ORIGINATION FORM

Proposed Revisions to a Standard Plans Index
(Please provide all information — Incomplete forms will be returned)

Index Number: 509-100

Index Title: Advance Warning For R/R Crossing

New Table
TYPICAL PLAN

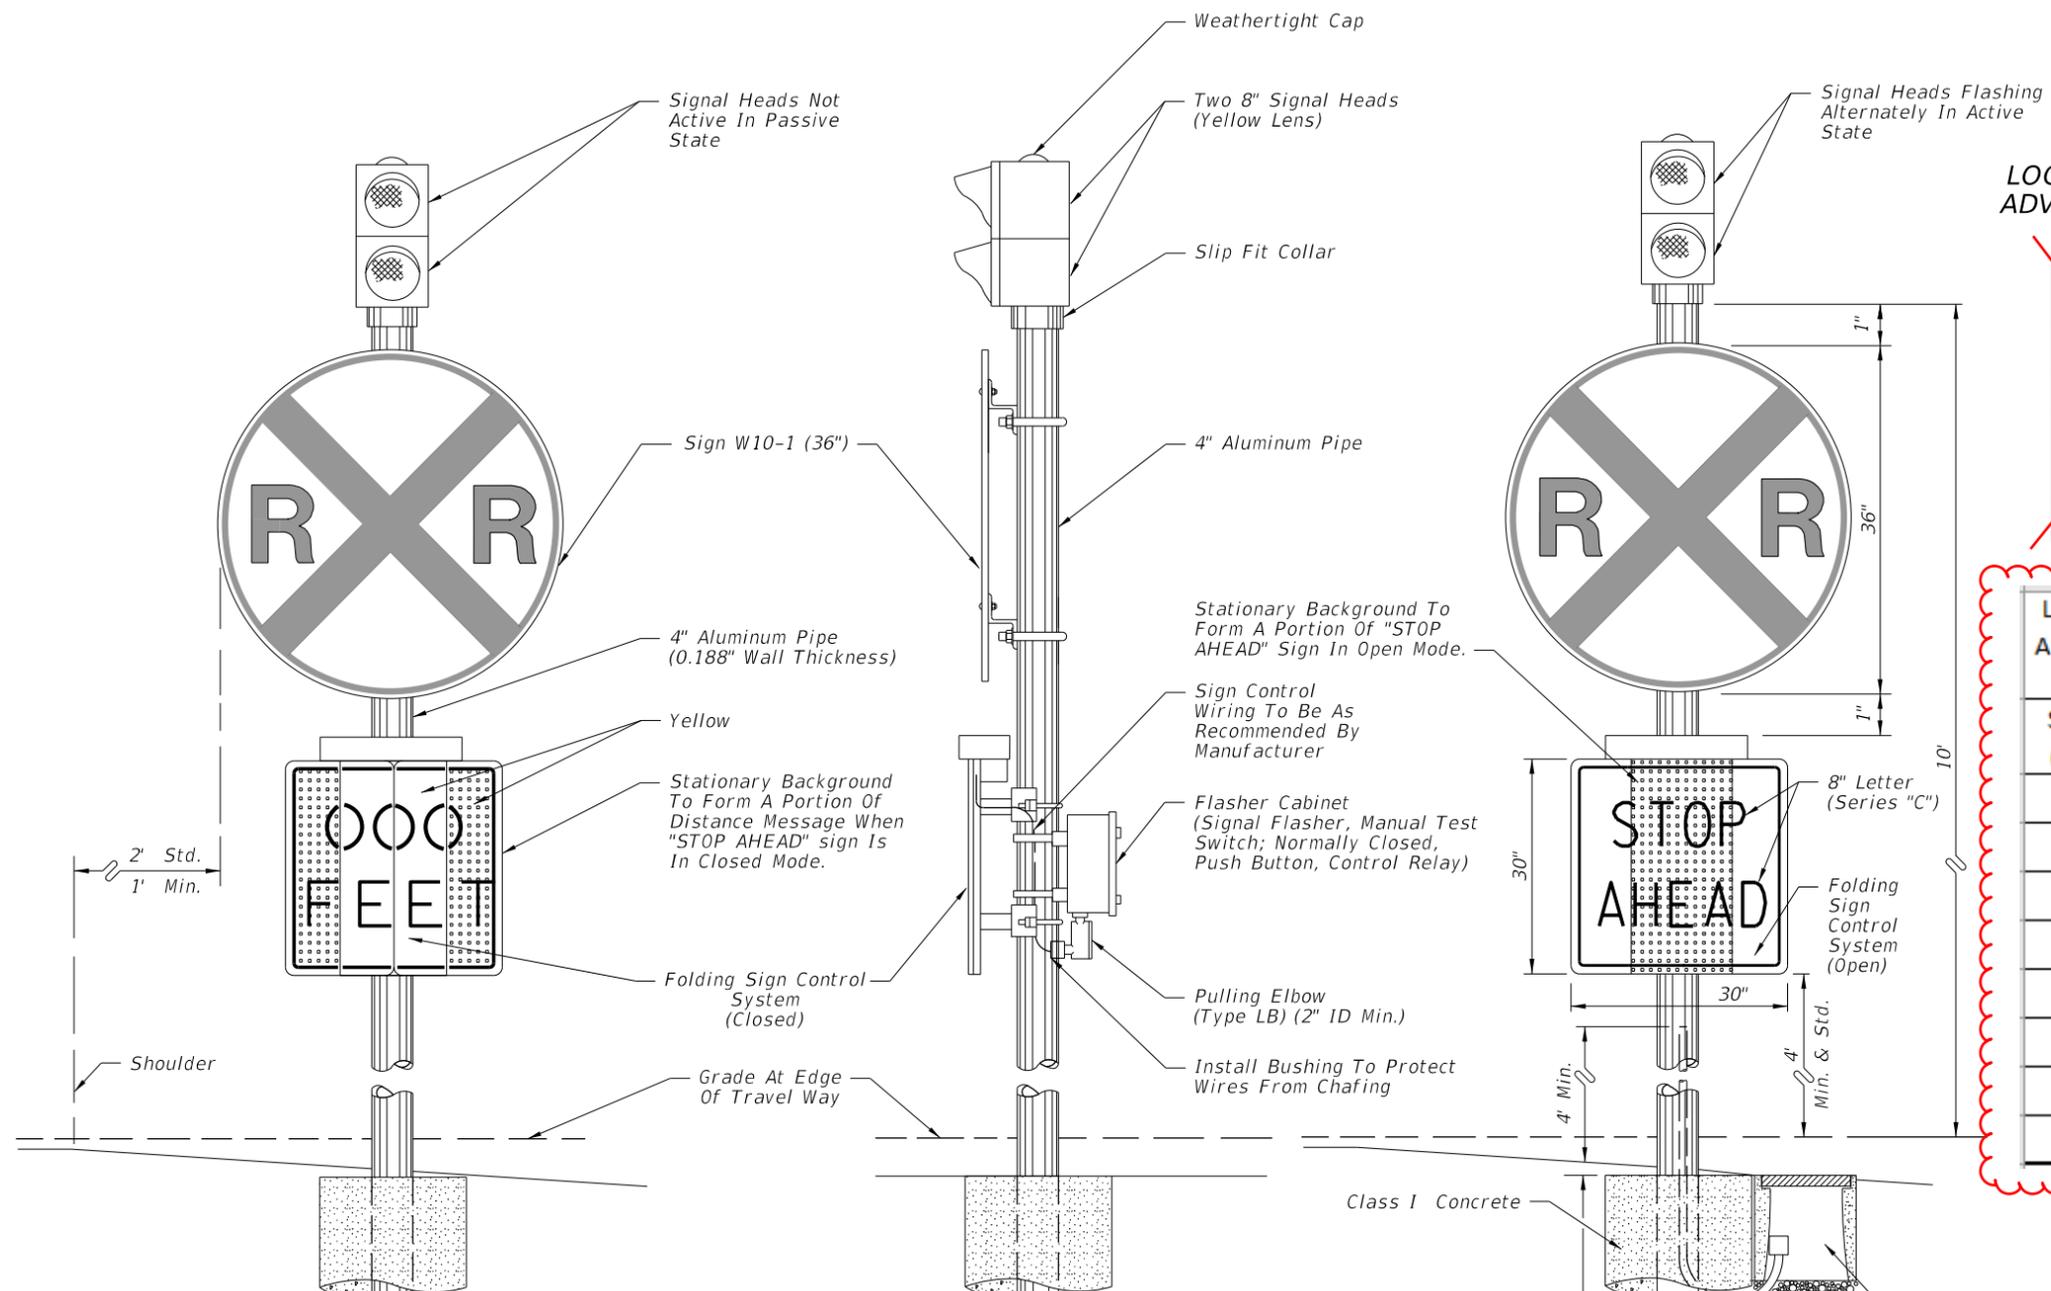
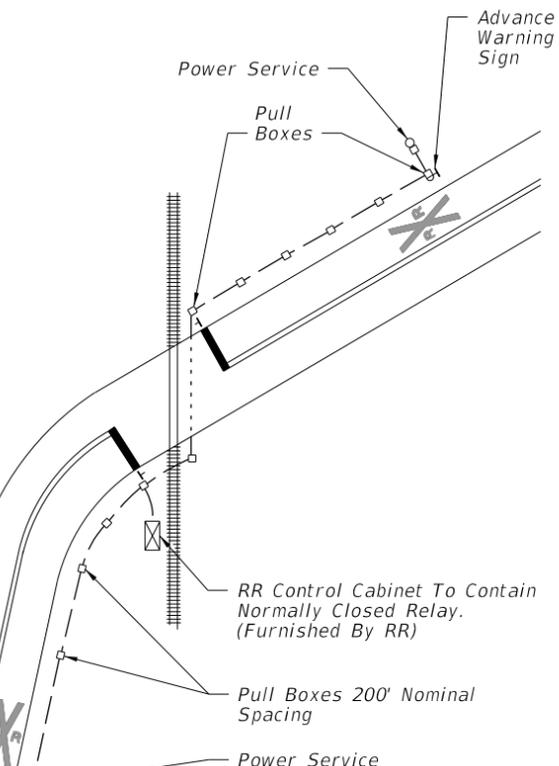
Changed table to match MUTCD and index 509-070.

SPEED (mph)	DISTANCE (ft)
Min.	50
30	75
40	125
50	250
55	325

Speed (mph)	Distance (ft)
Min.	50
30	100
35	100
40	125
45	175
50	250
55	325
60	400
